Airport *Link*

Request for Project Change

MAY 2008

Queensland
Government

Airport Link Overall Route Plan - Changed Project

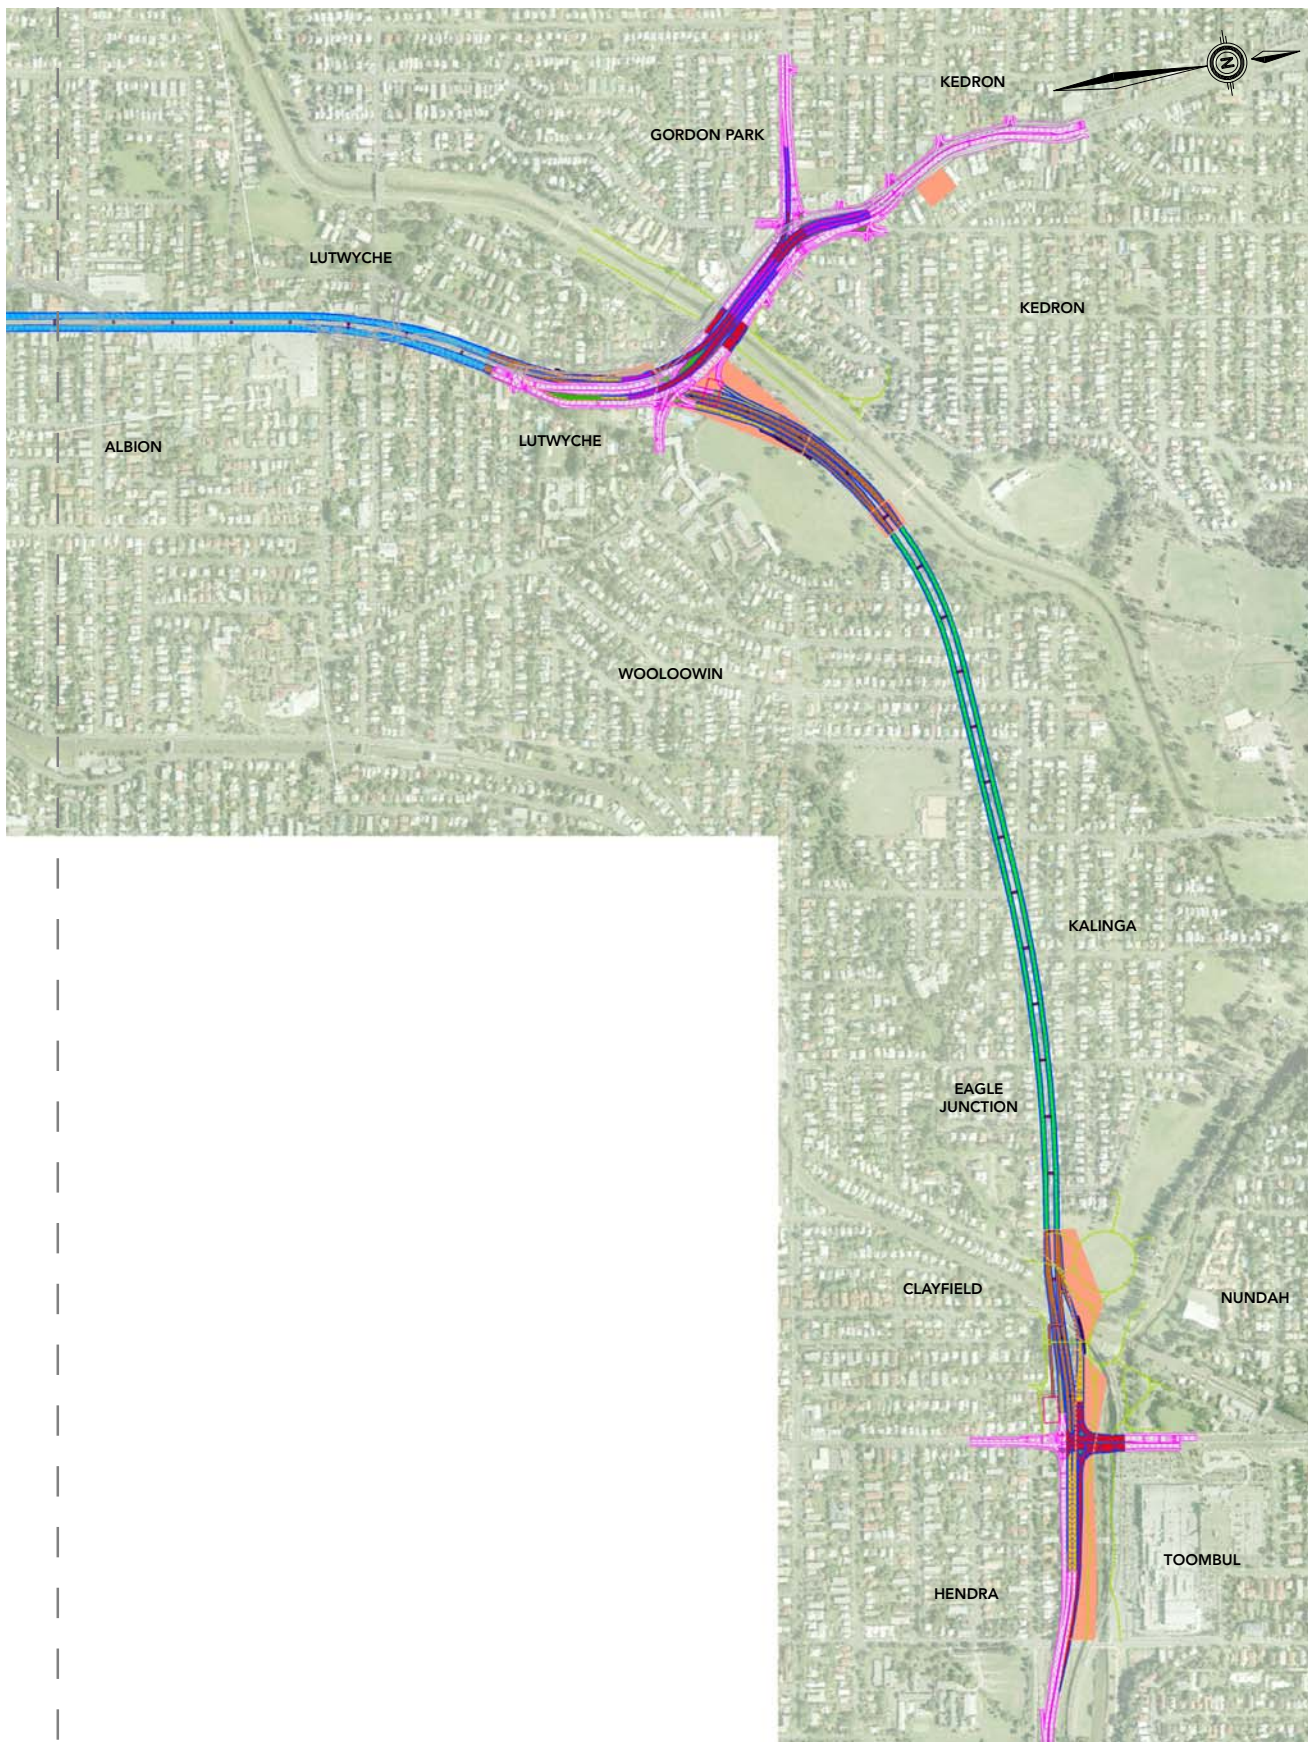
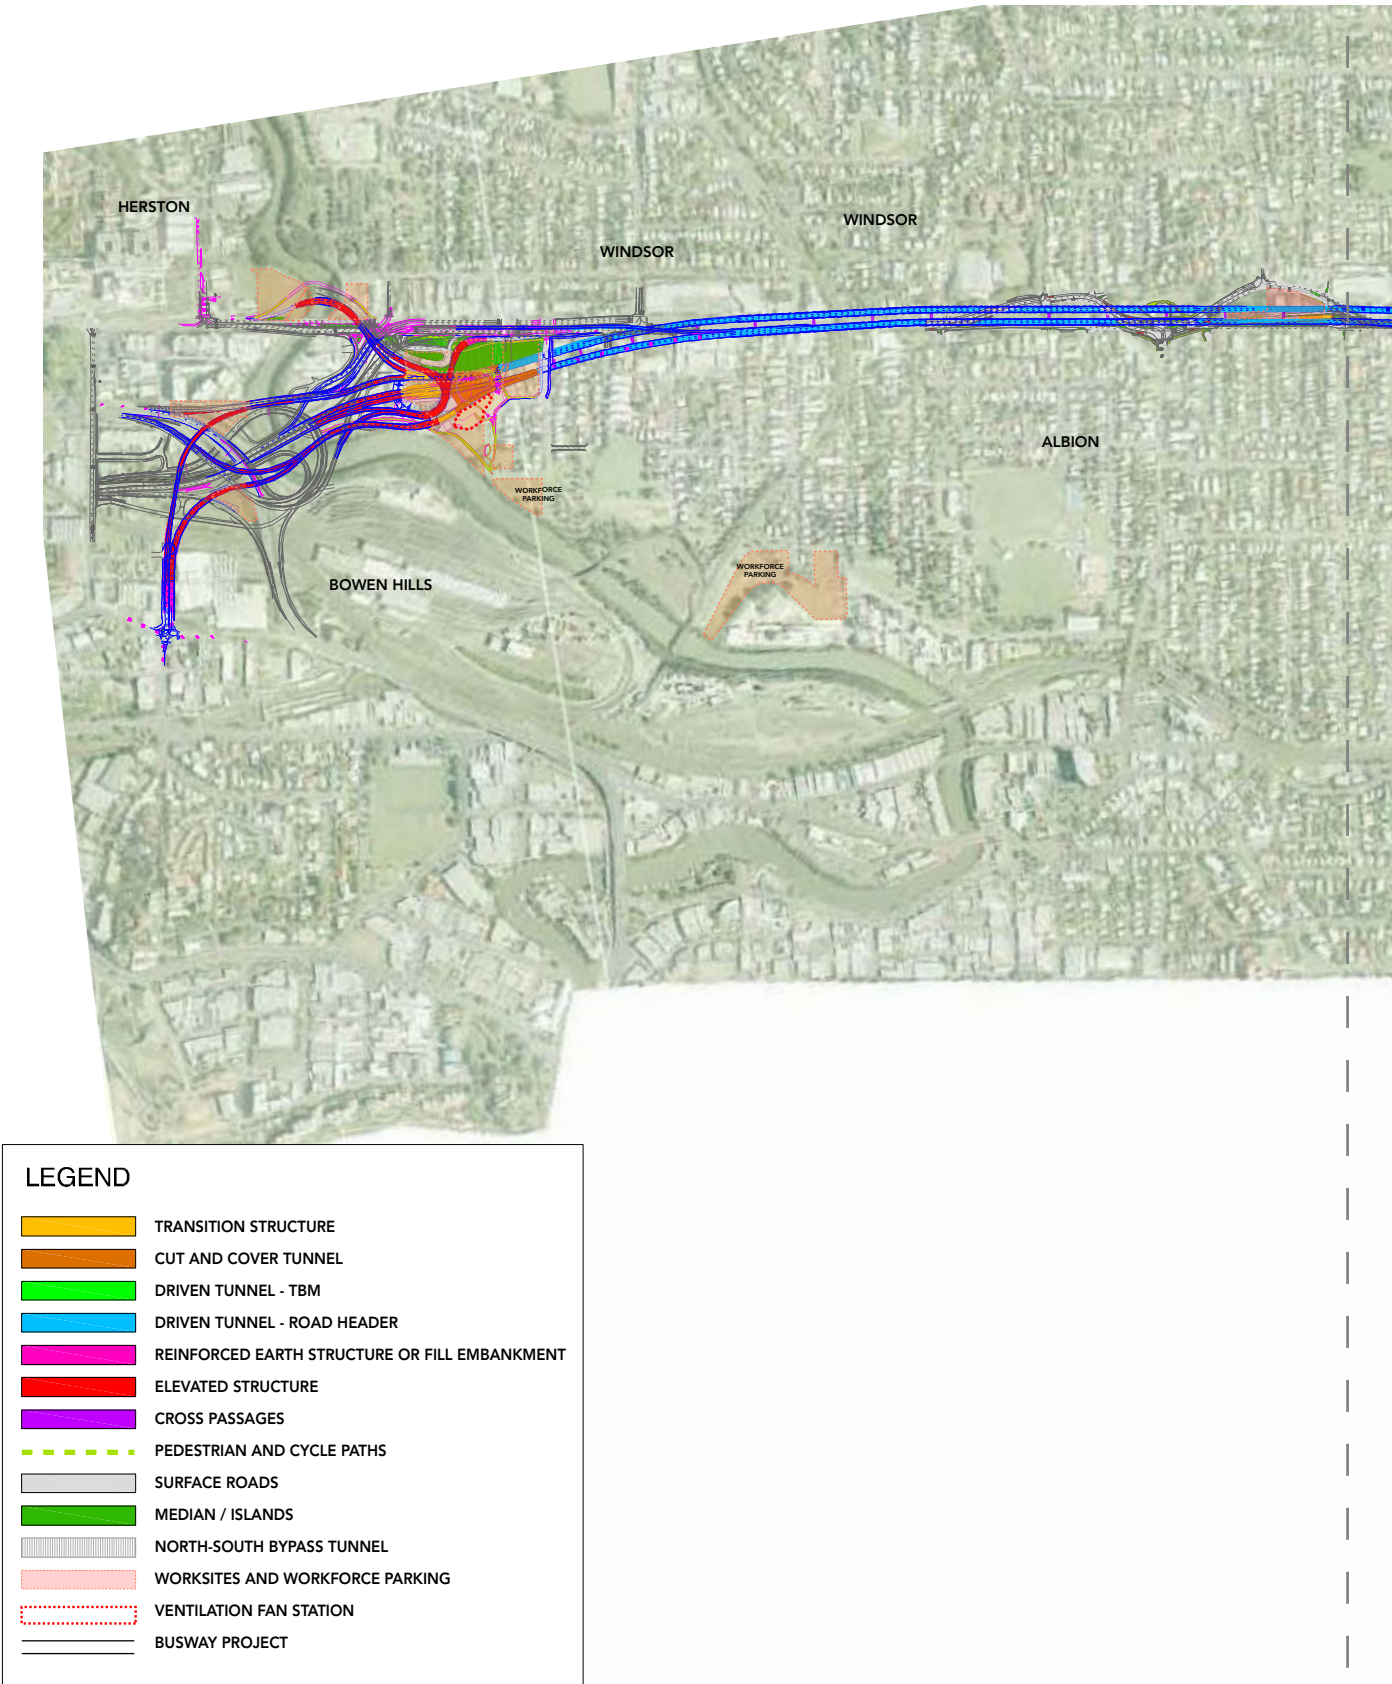
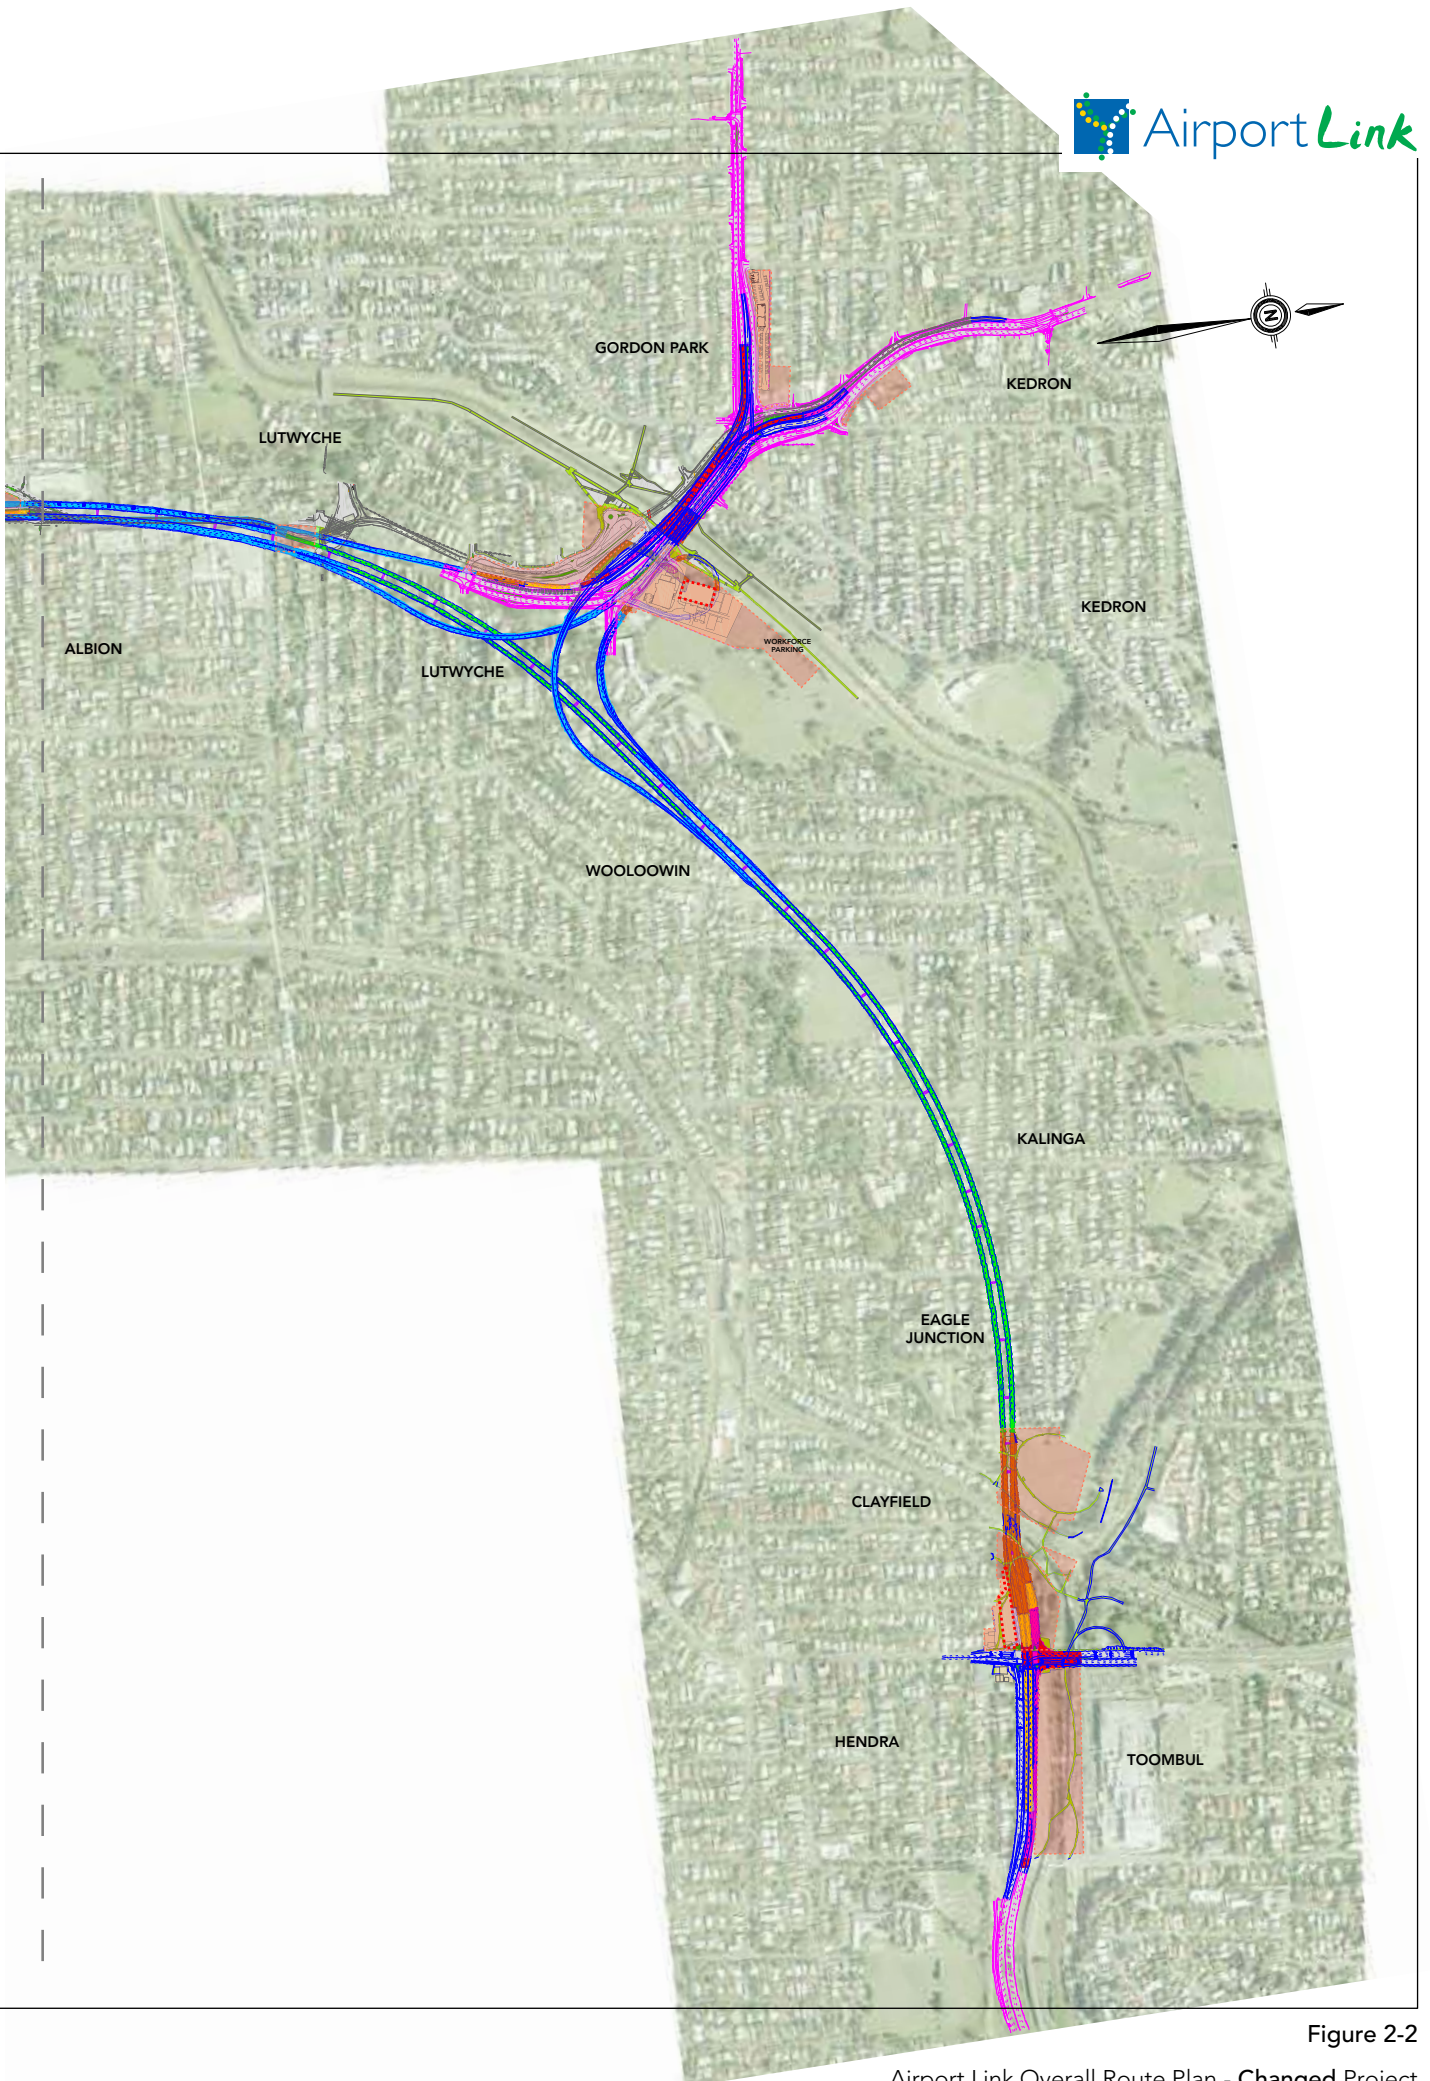
The proposed design changes to the Reference Project **Figure 2-1** are shown generally in Overall Route Plan **Figure 2-2**, and are:

- physical changes to the surface road connections and interchange alignments at Bowen Hills and Windsor to improve their efficiency, reduce impacts on The Mews apartments compared to the Reference Project, provide for better use of existing infrastructure and mitigate impacts on the riparian corridor of Enoggera Creek and the Queensland Rail infrastructure, as follows:

- relocation of the O'Connell Terrace on-ramps adjacent to The Mews apartments to a ramp structure off the north-bound lanes in Bowen Bridge Road, north of Butterfield Street, providing an elevated crossing over Lutwyche Road to the north bound mainline Airport Link tunnel. The elevated ramp would also provide grade separated access to the NSBT and the ICB replacing the controlled right hand turn movement from Lutwyche Road proposed in the Reference Project and utilising the downstream NSBT bridge to access the ICB;
